**ADDENDUM No. 4**

<b>Project</b>	T.A. Blakelock H.S. Renovations - Phase 1	<b>Project No.</b>	2215A
<b>Location</b>	1160 Rebecca Street, Oakville, Ontario	<b>Date of Issue</b>	2023 04 03
<b>Owner</b>	Halton District School Board	<b>File</b>	2215/7.1.3

**A4-2 DRAWING NO. 300 LEVEL 0 REFLECTED CEILING PLANS AND DETAILS (reissued)**

Drawing Title:  
**LEVEL 1 REFLECTED CEILING AND FLOOR FINISH PLANS**

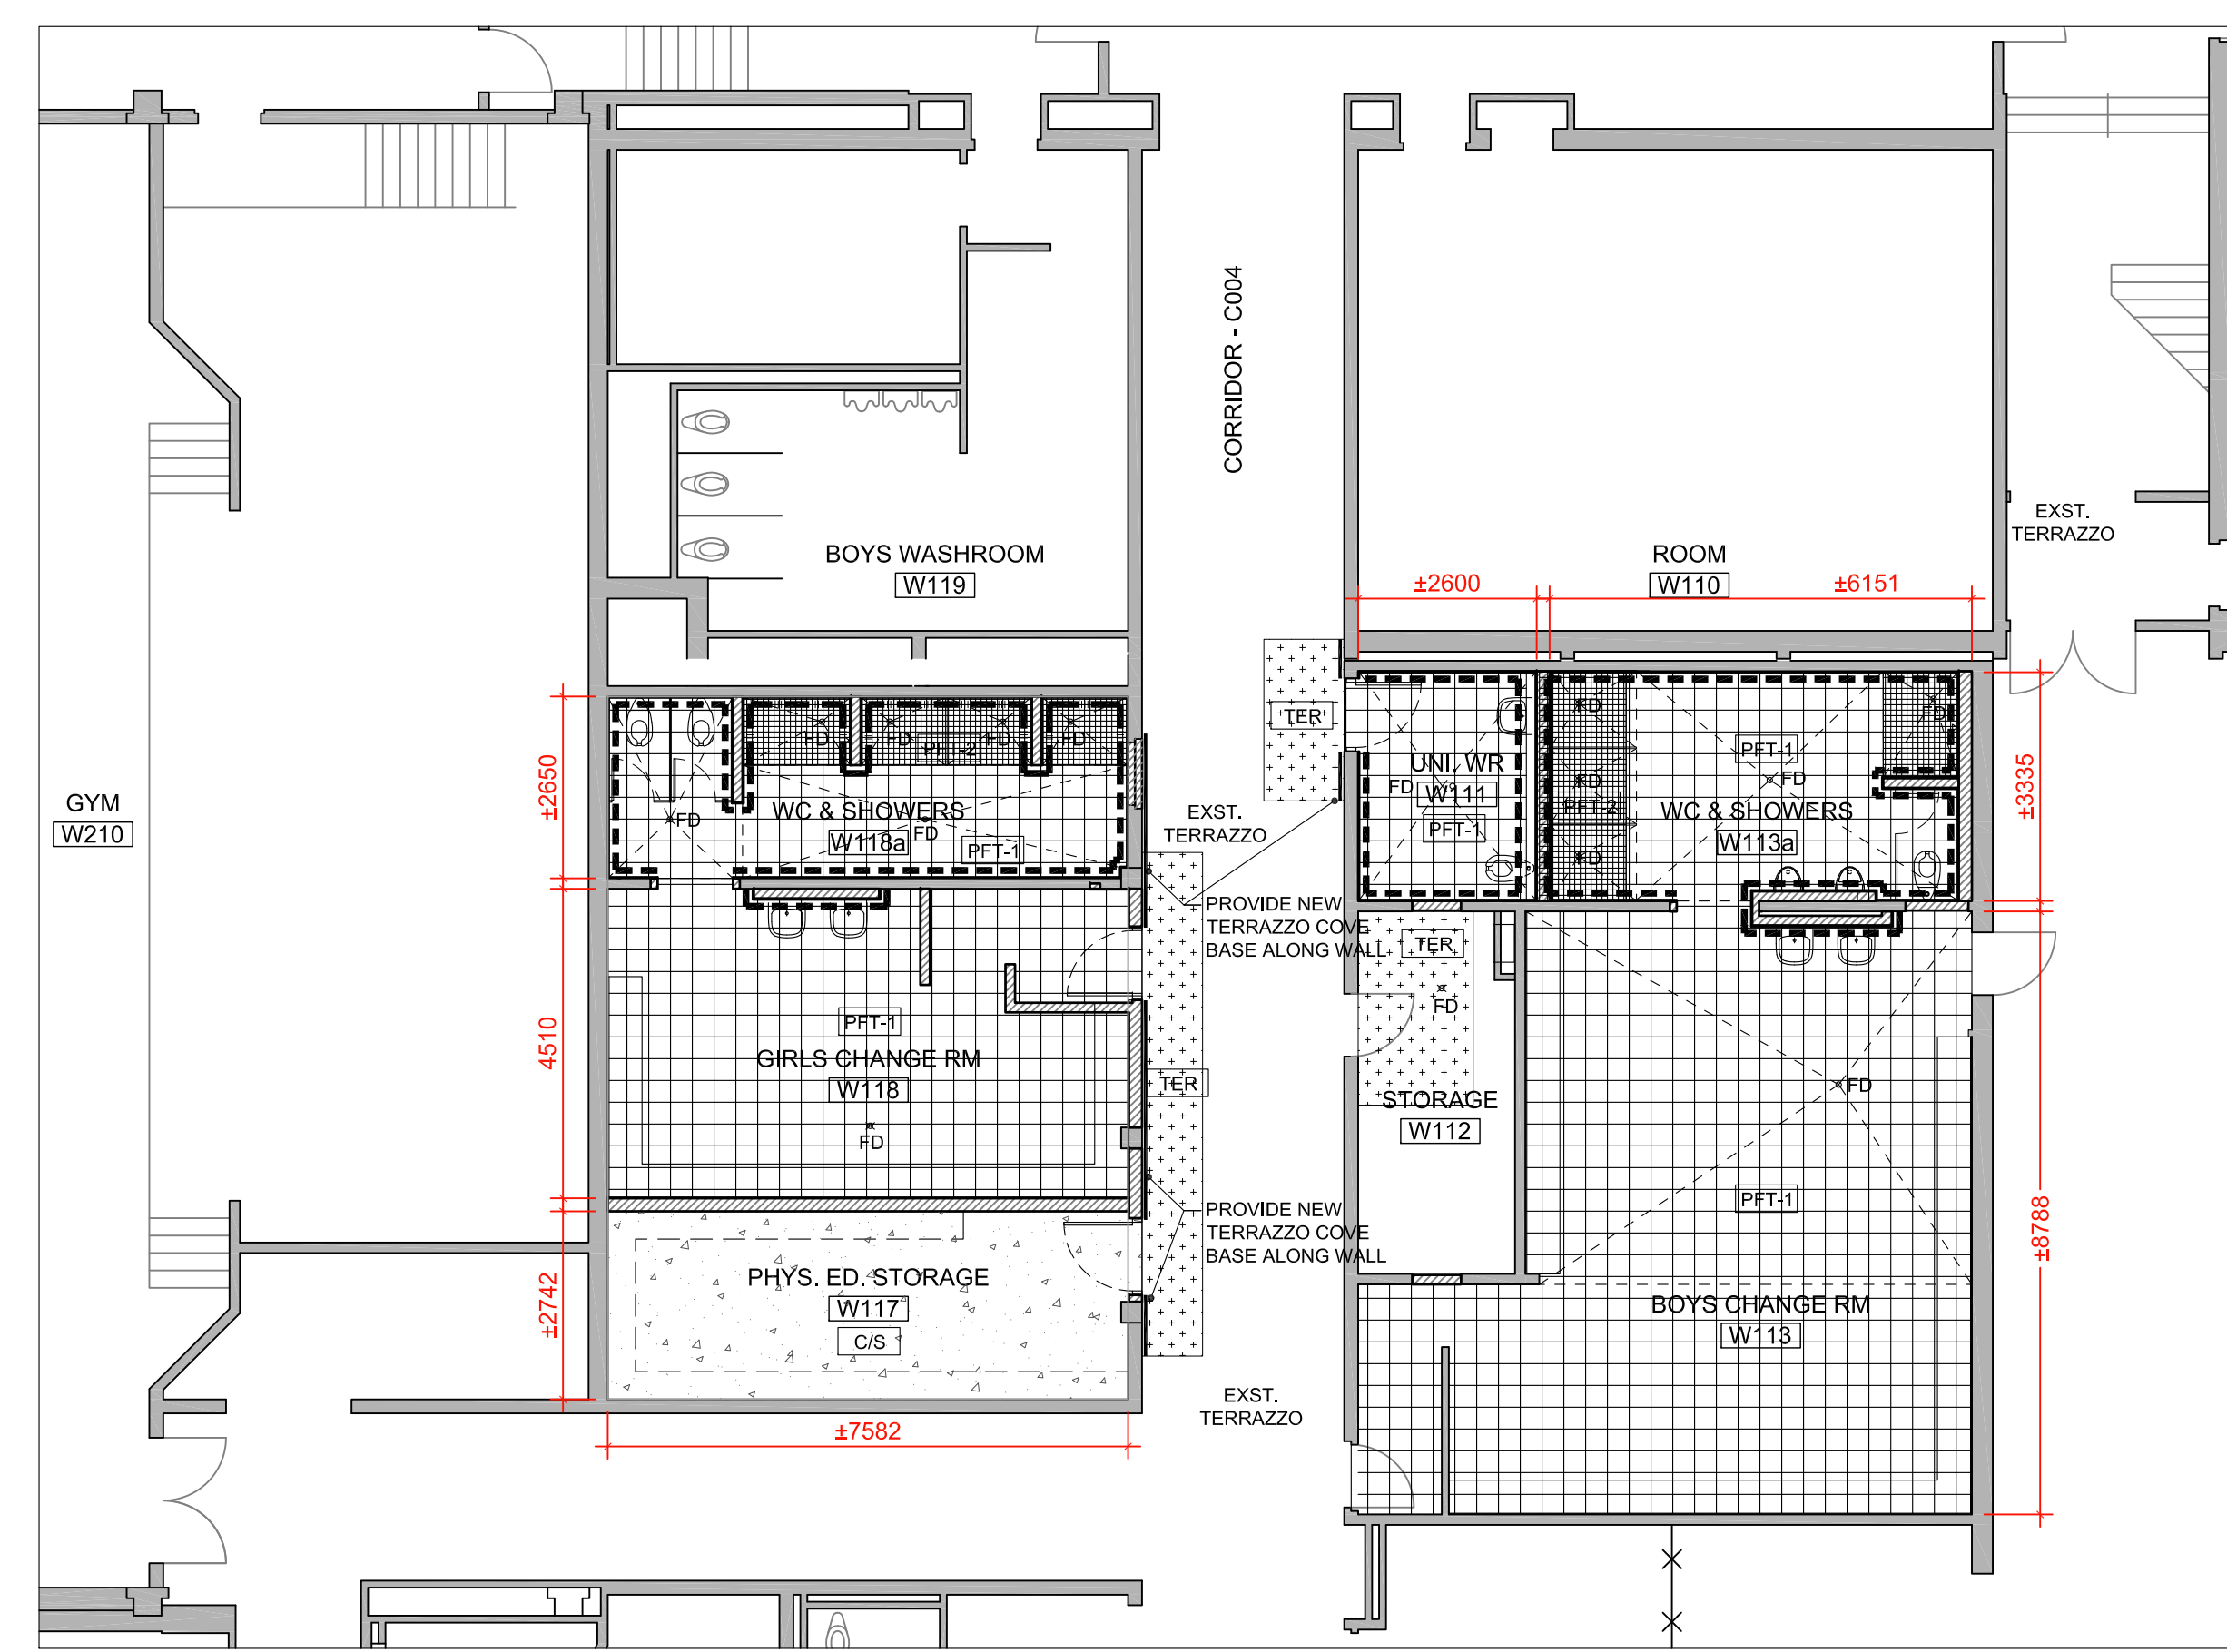
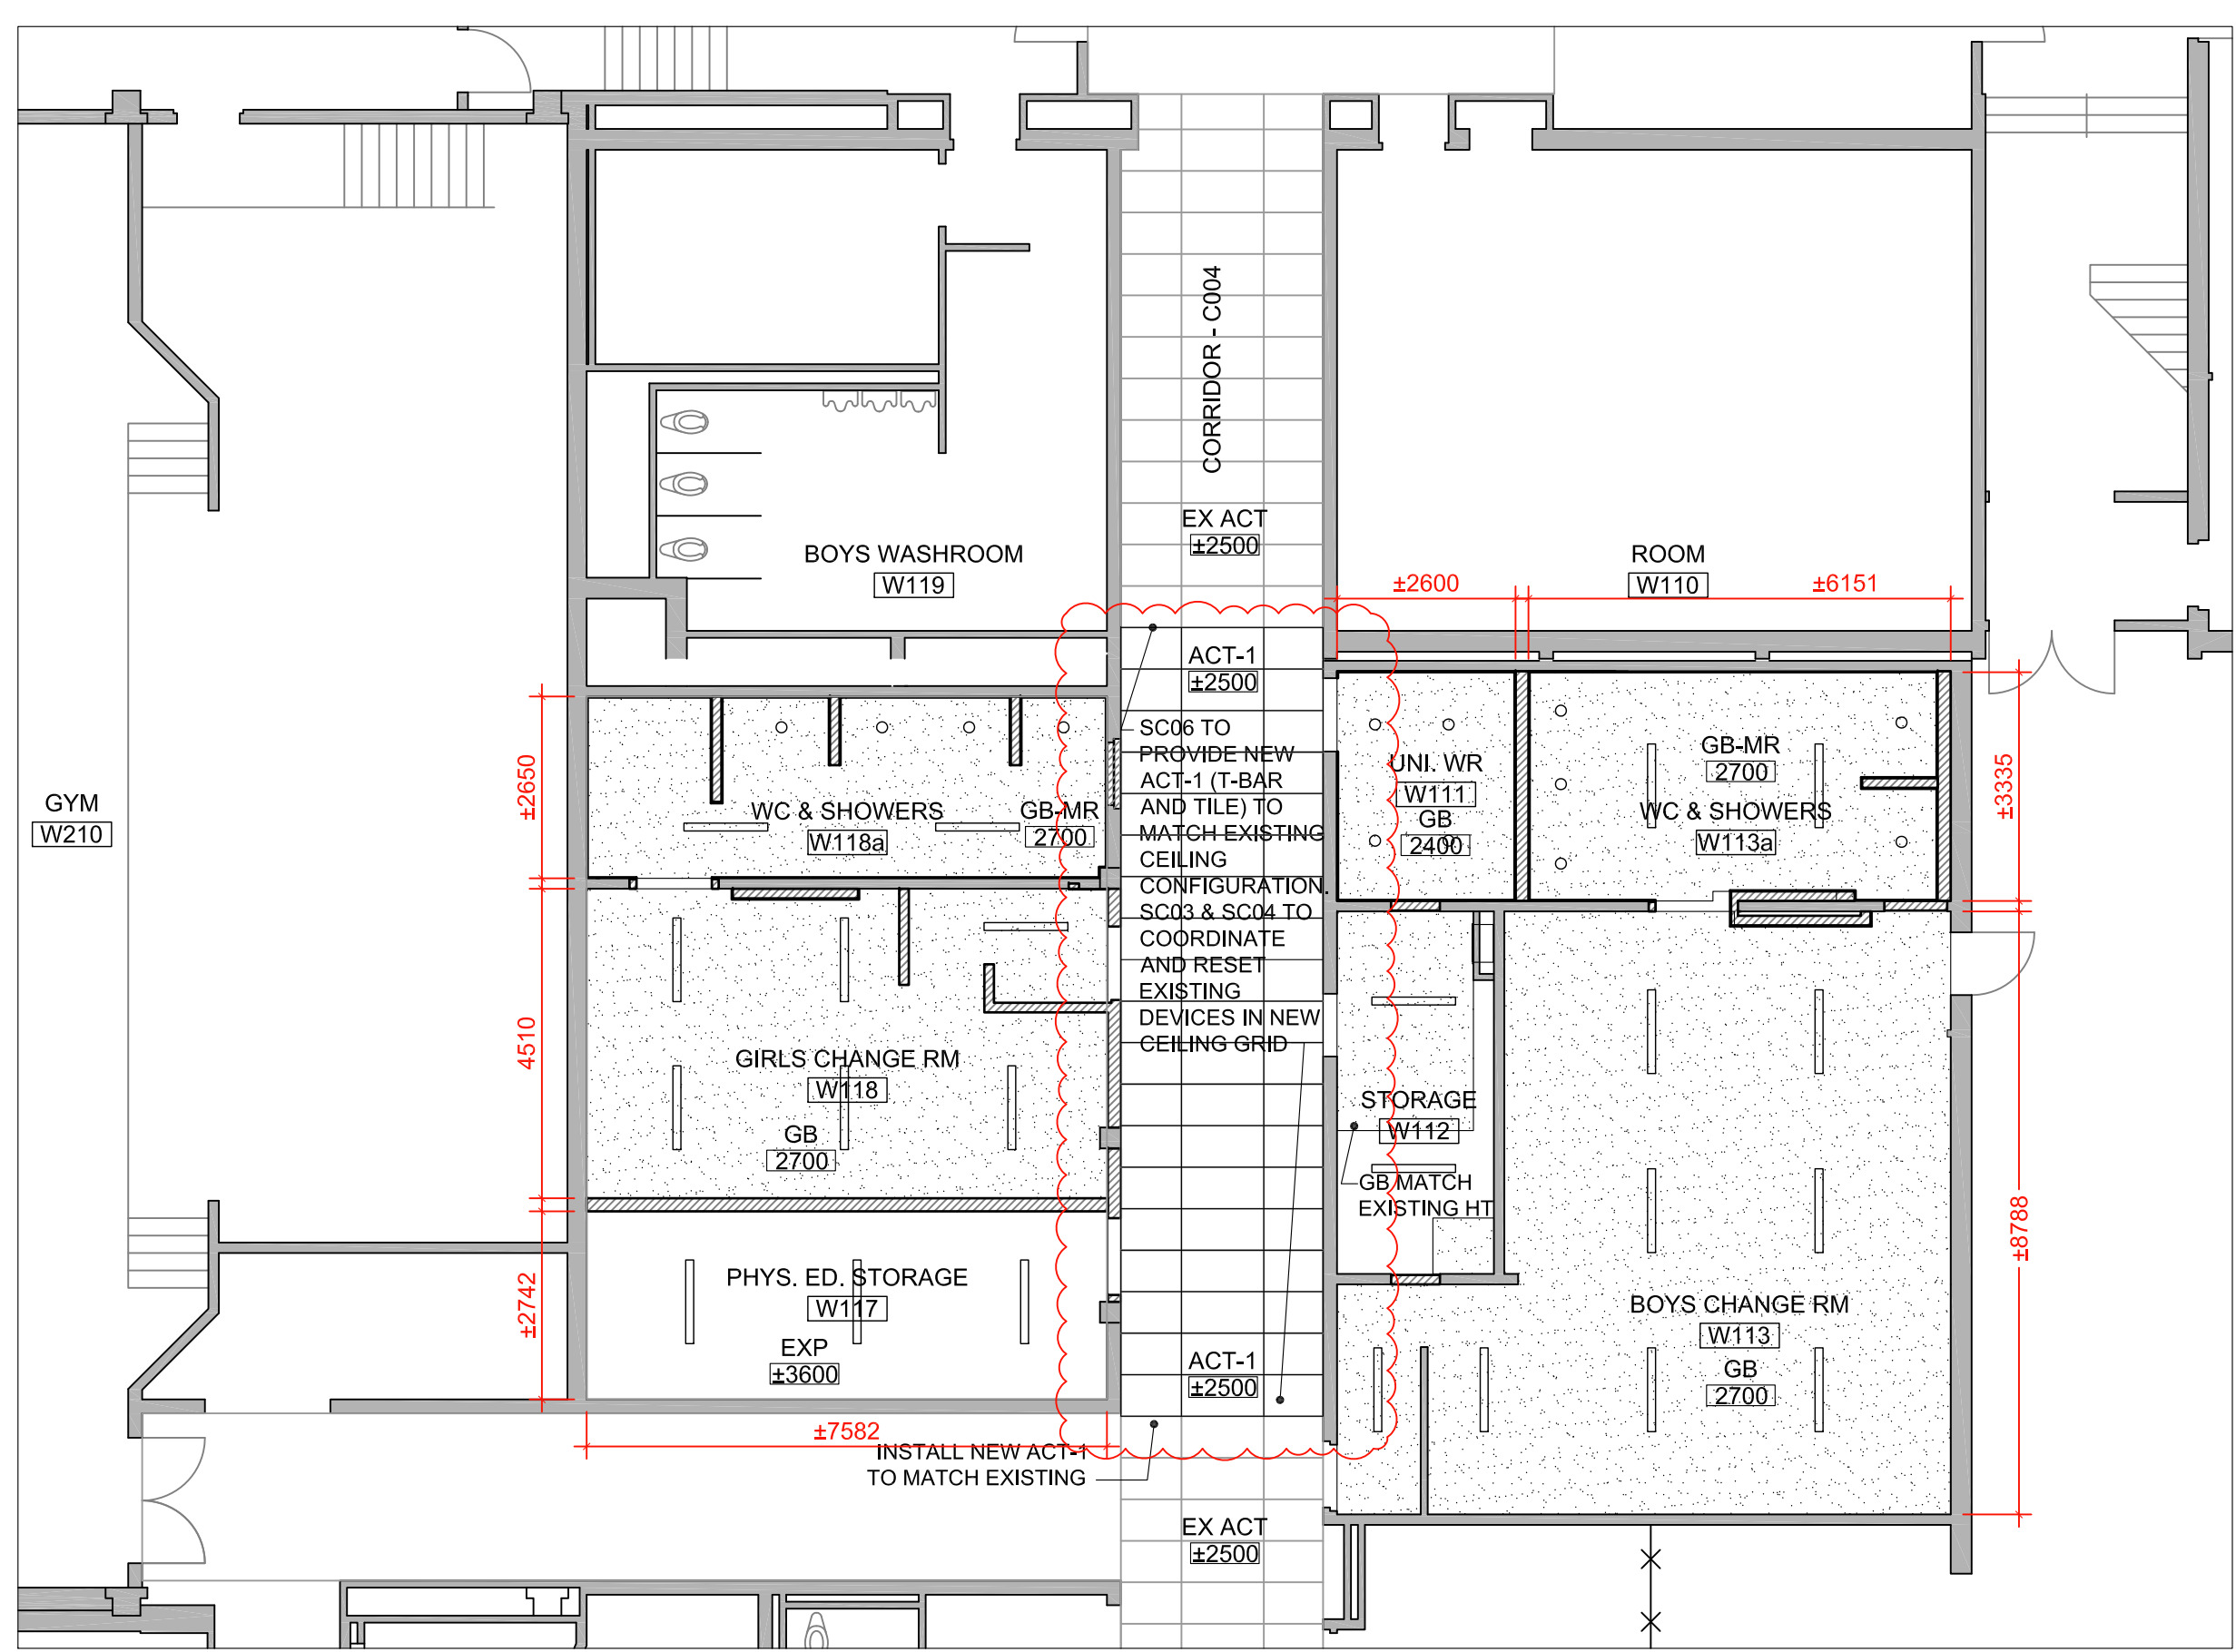
- .1 Replace drawing with the attached Revision No. 2.
- .2 Revisions include the following:
  - .1 Ceiling replacement in Corridor C004; SC06 DRYWALL & ACOUSTICS to provide new ACT-1 (T- bar and tiles) to match existing ceiling configuration. SC03 MECHANICAL & SC04 ELECTRICAL to coordinate and reset existing devices in the new ceiling grid.
  - .2 Additional ceiling dimensions in red.
  - .3 Added 'Room Finish Notes' similar to A301 from Addendum No. 1
